Charter Township of Garfield Planning Department Report No. 2023-5		
Prepared:	January 3, 2023	Pages: 6
Meeting:	January 10, 2023 Township Board	Attachments: <input checked="" type="checkbox"/>
Subject:	SPR 2022-16 Birmley Hills Site Condominium – Township Board Review	
File No.	SPR 2022-16	Parcel No. 05-026-020-30
Owner:	T&R Investments, Steve Zakrajsek	
Agent:	Boyne Engineering and Design

RE: Birmley Hills Site Condominium – T&R Investments
Water Main and Sanitary Sewer Extension, Plan Review
GFA No. 22300

**BIRMLEY HILLS DRIVE
PLAN & PROFILE**

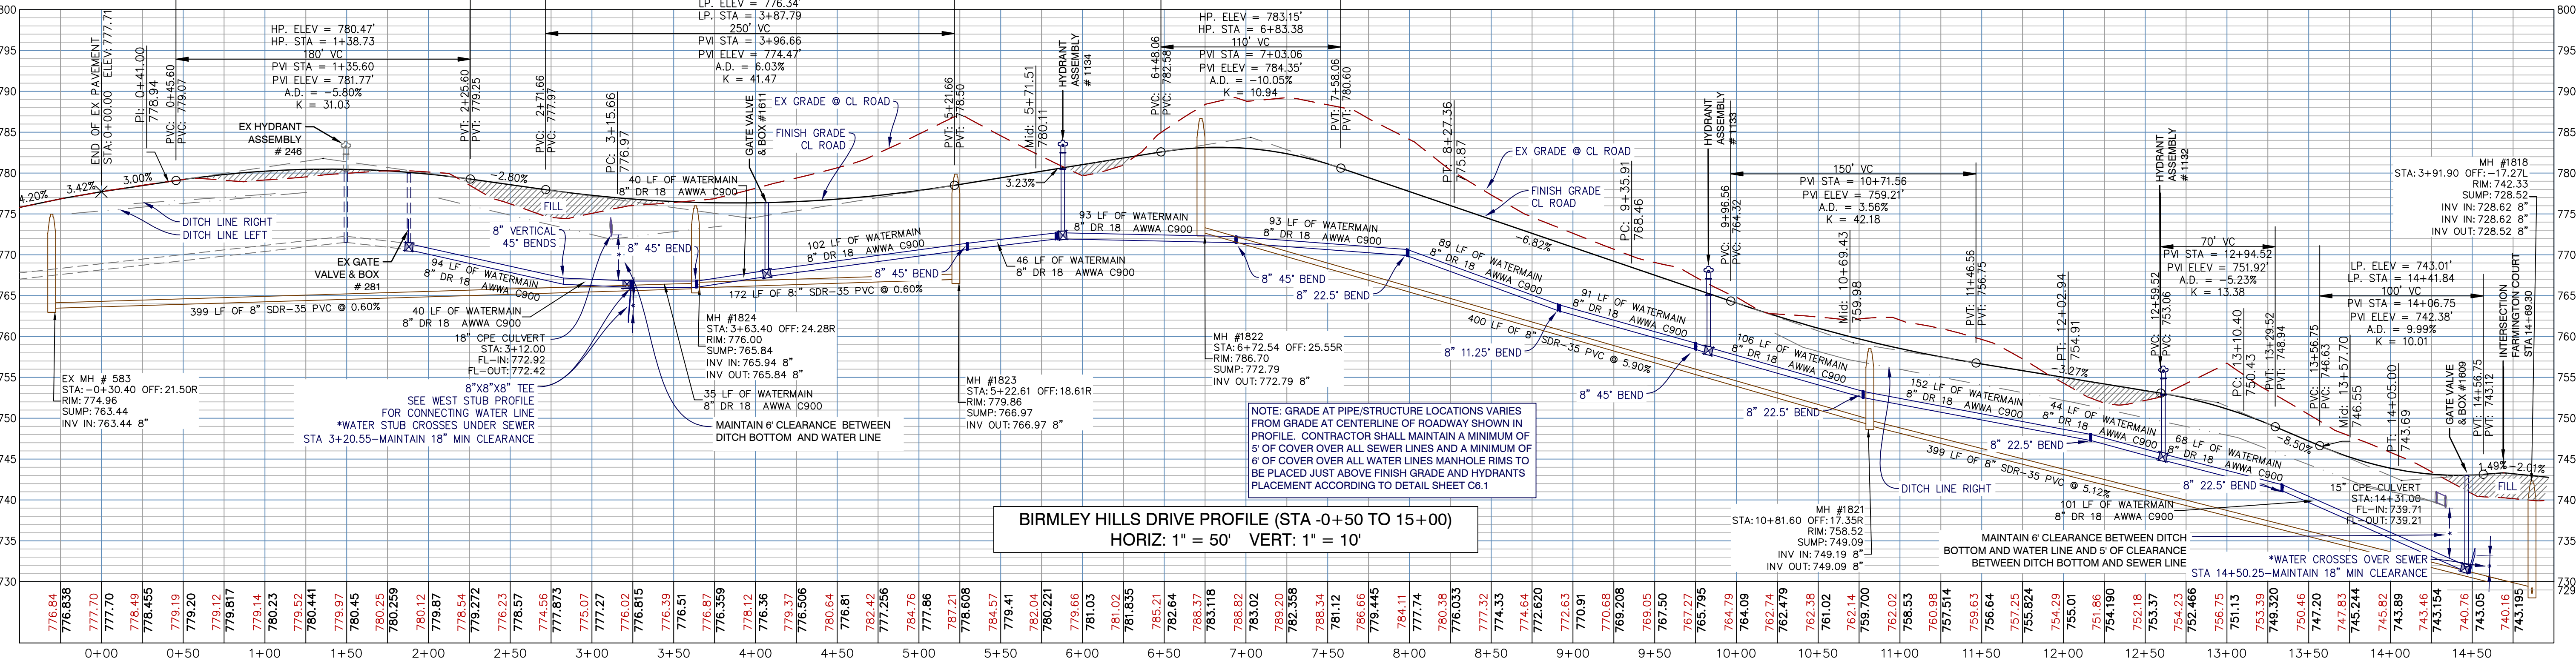
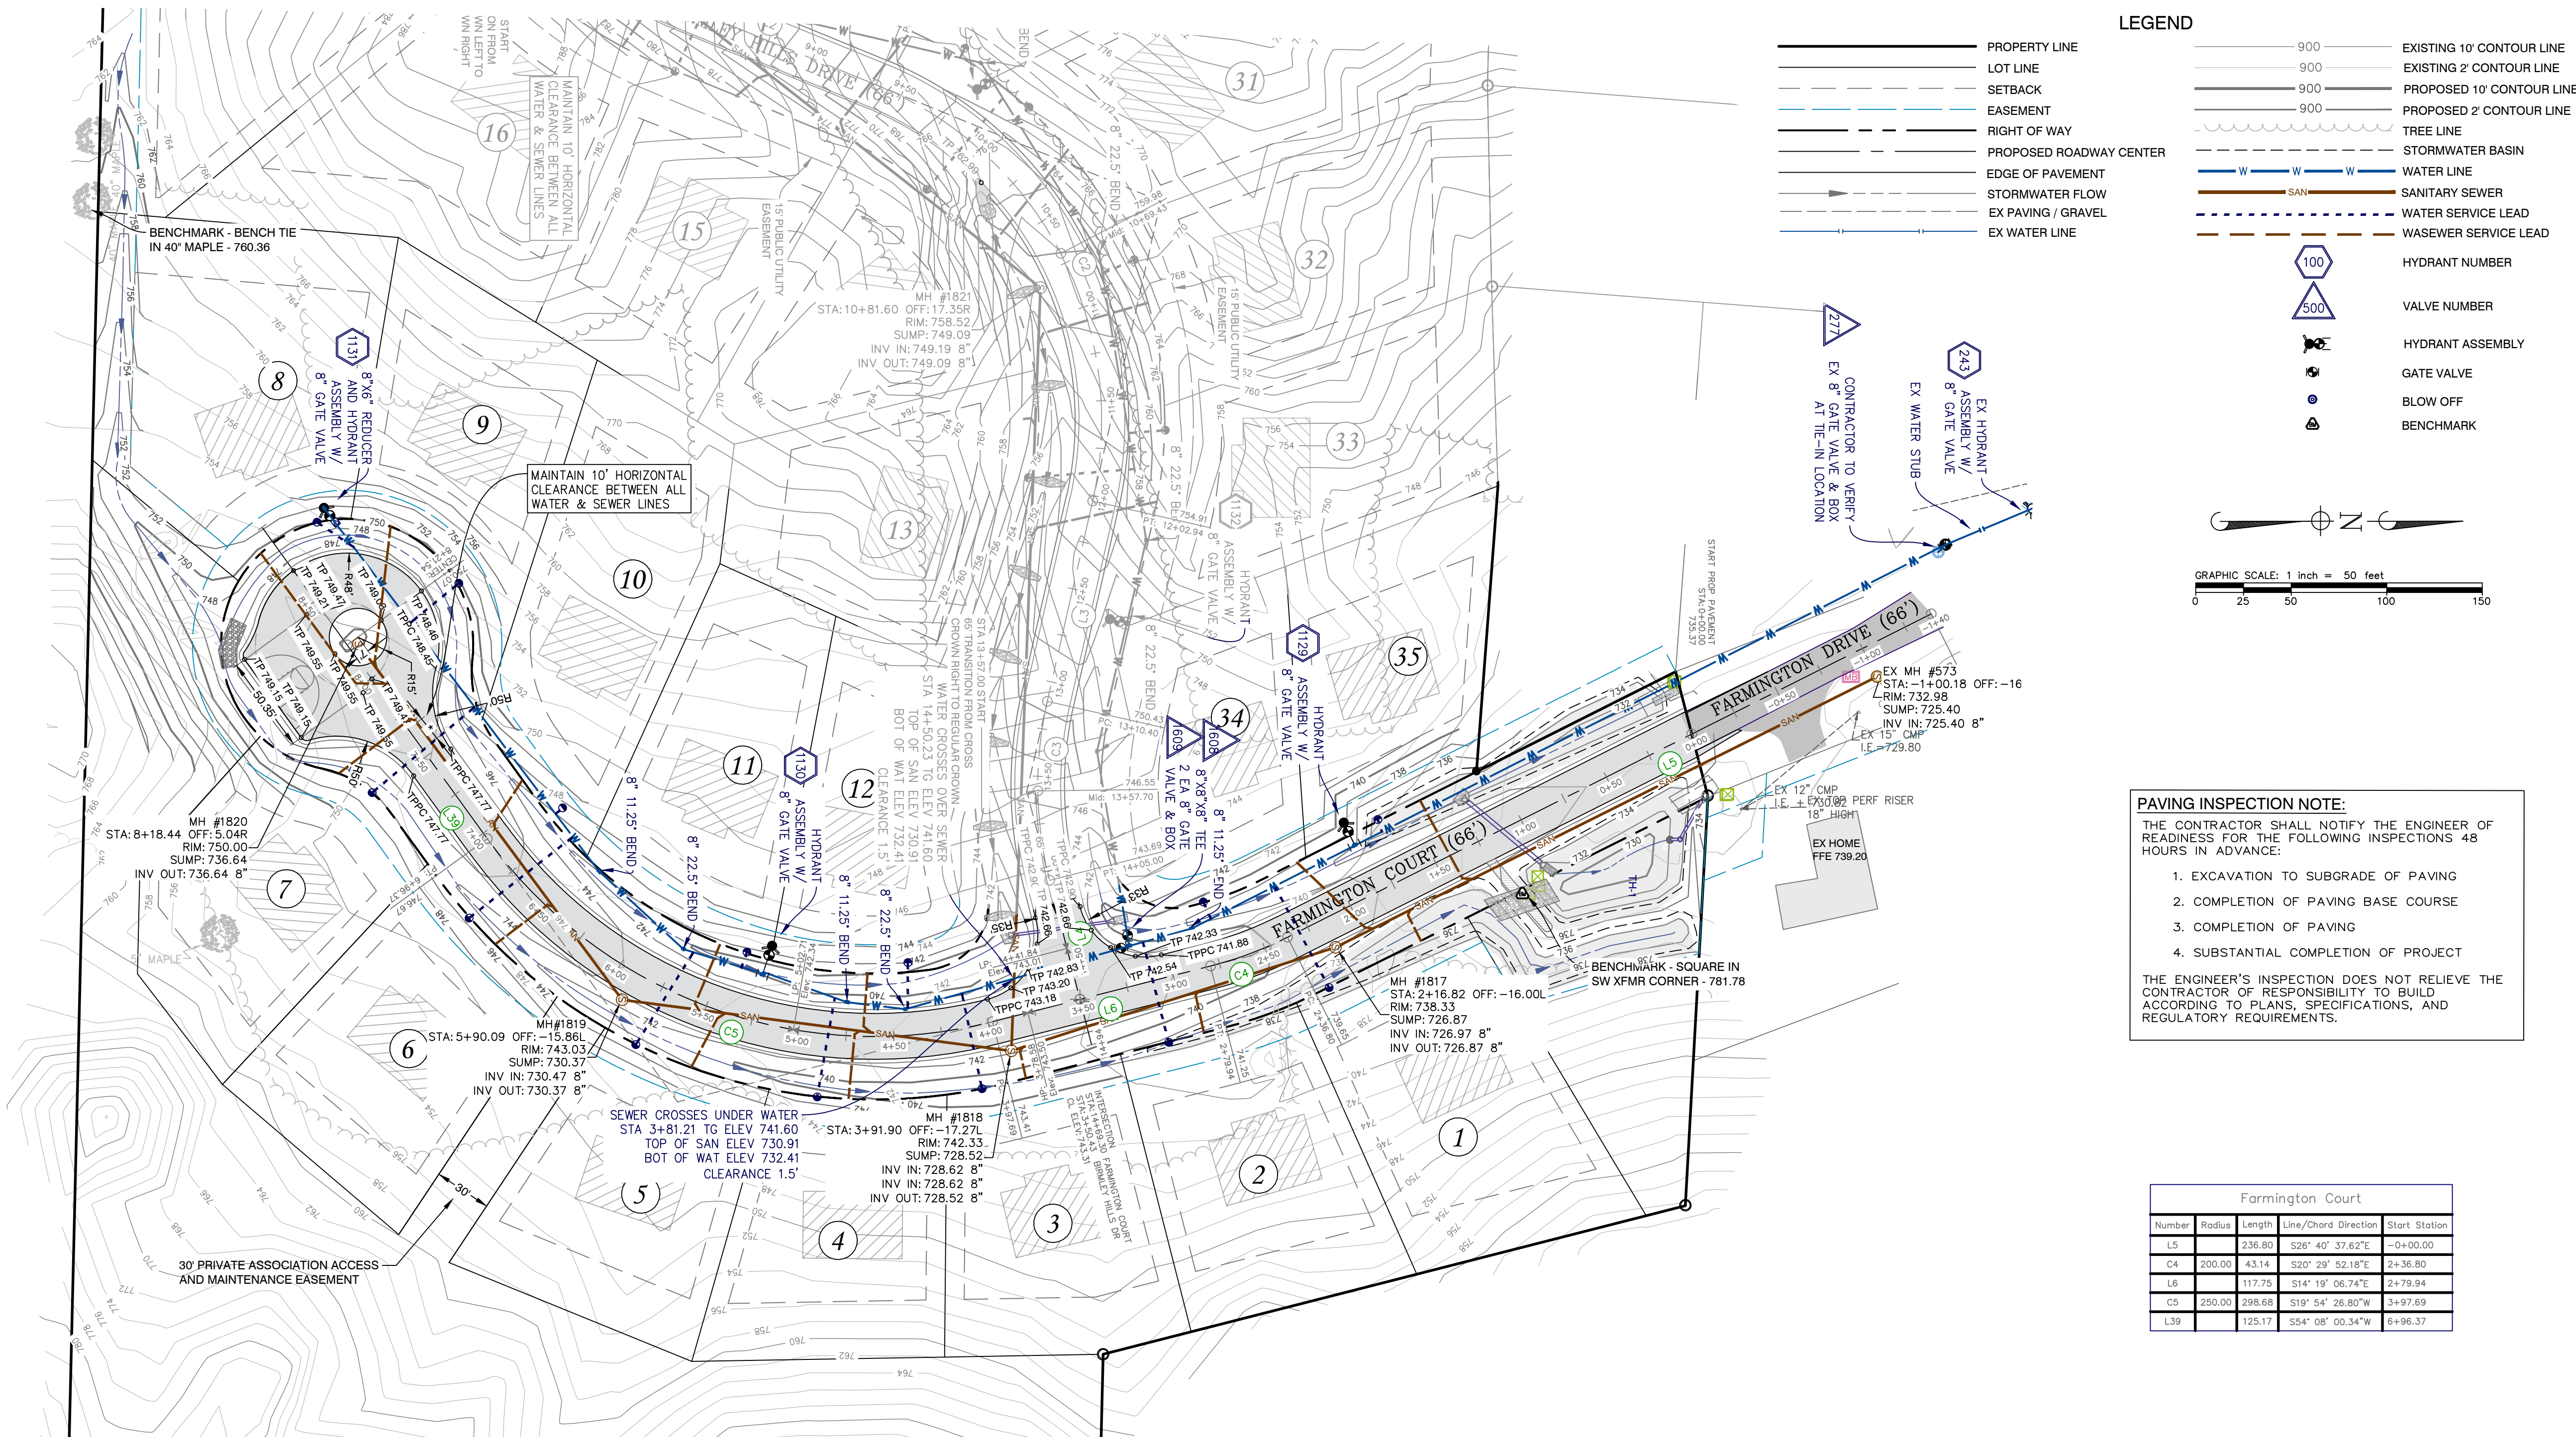
5. Water main stub shall be provided to the abutting western parcel to accommodate a future access.
6. A main line valves shall be installed on Sheet C4.0. Valves are to be installed every 1,000 feet to accommodate isolation.

FARMINGTON COURT
PLAN & PROFILE

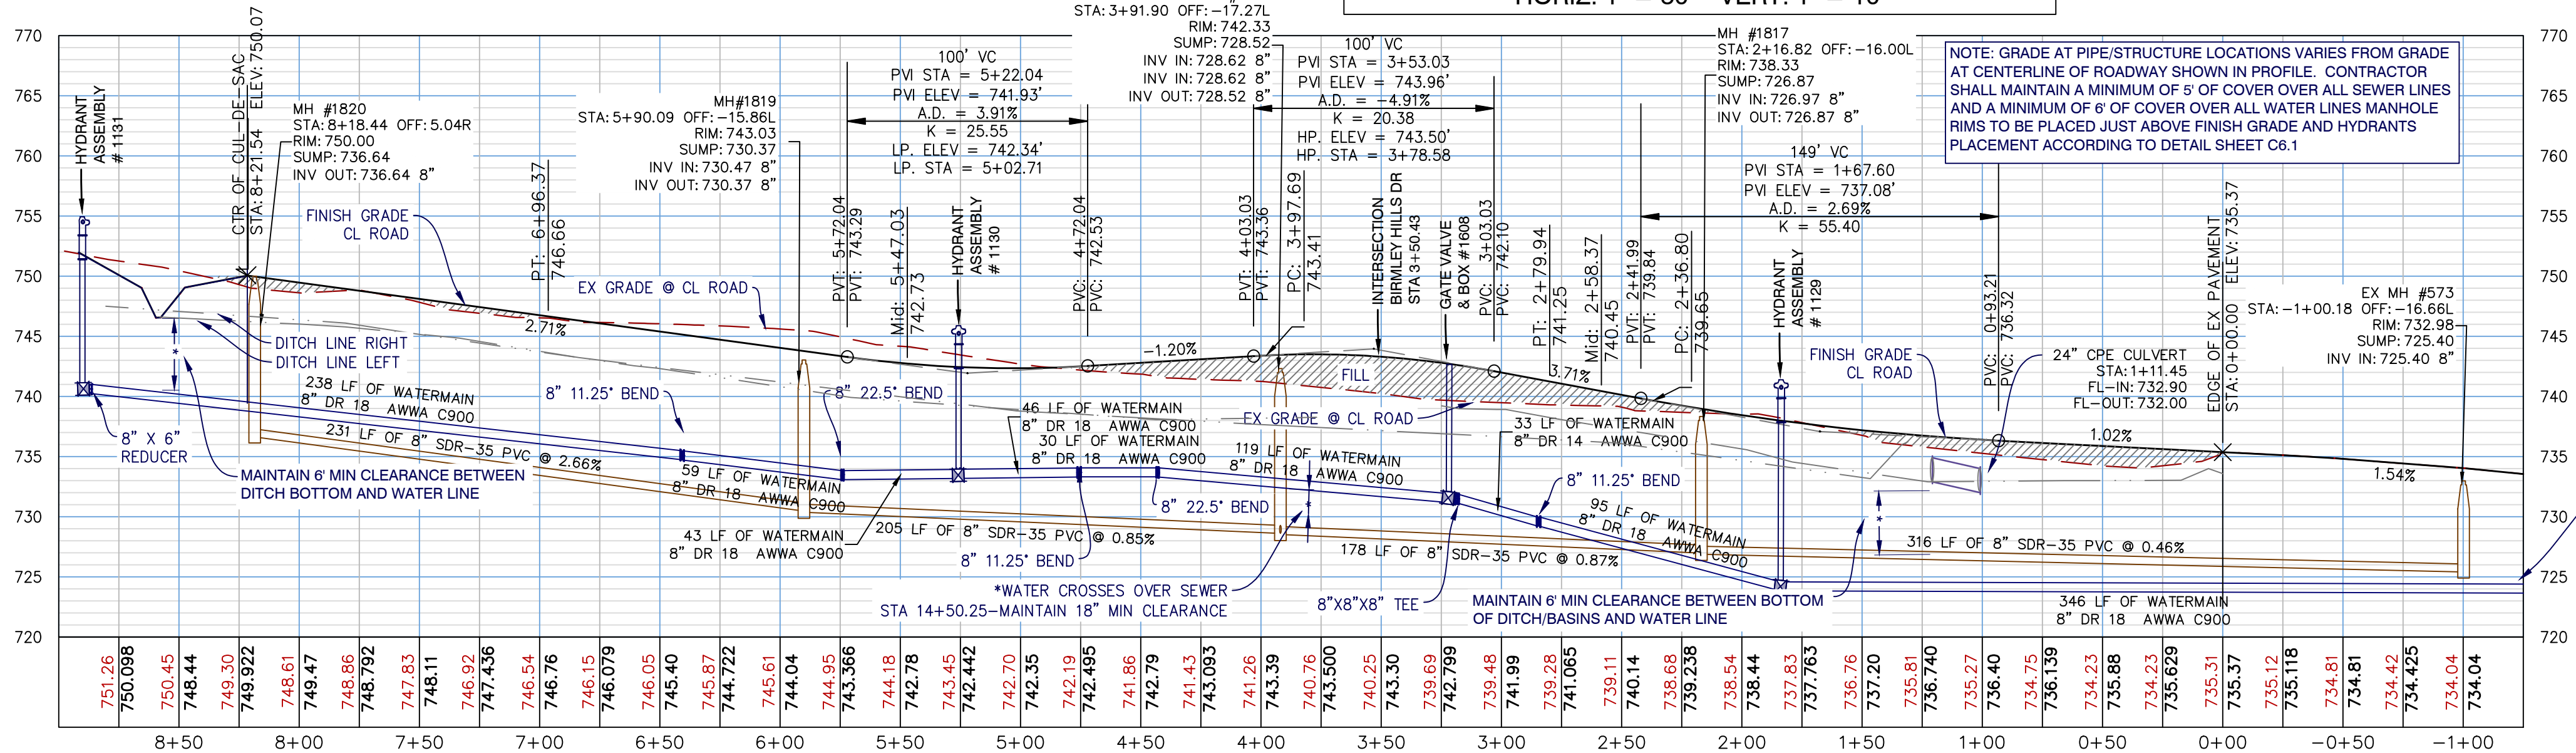
3. Please note that C900 DR 18 is a minimum requirement and DR 14 is proposed.
4. Sheet C4.1 profile sta. 3+25 to 2+75 water main length not called out.
